350 CEMENT CONCRETE PAVEMENT SPECIFICATION
COMMENTS FROM INTERNAL/INDUSTRY REVIEW

Comments: (Internal 12/4/19)

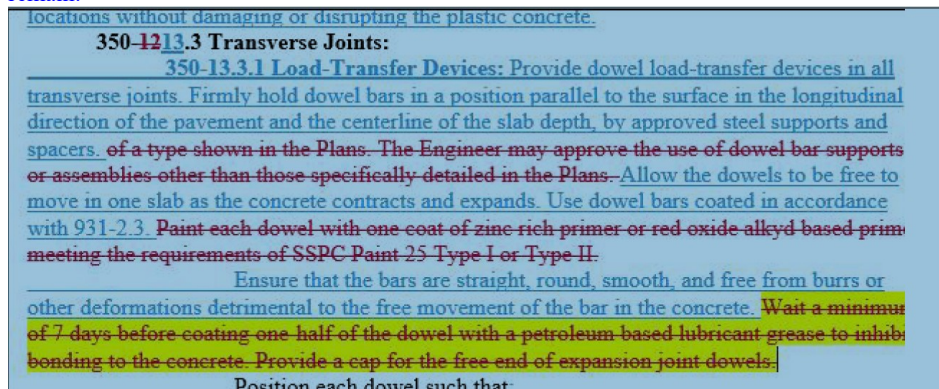
In 350-13.3.1 Load Transfer Devices, they are proposing to eliminate the Spec language that requires greasing (lubricating) half of each dowel bar. I recommend we allow that requirement to remain. My reasoning is that it is important for the slabs to be able to expand and contract independent of one another and greasing the dowel bars helps ensure this occurs. There are other requirements regarding bar alignment that also helps, but greasing half the bar ensures only one half of the bar could possibly be constrained in a slab while the other end is free to move. Please see the screenshot below, I believe the Spec language they are proposing to delete (that I have highlighted in yellow) should not be deleted from the Specifications, this language should remain.

Response: We concur with Rich's comments below to keep the highlighted / strike though language in the proposed specification. Change was made prior to Industry review.
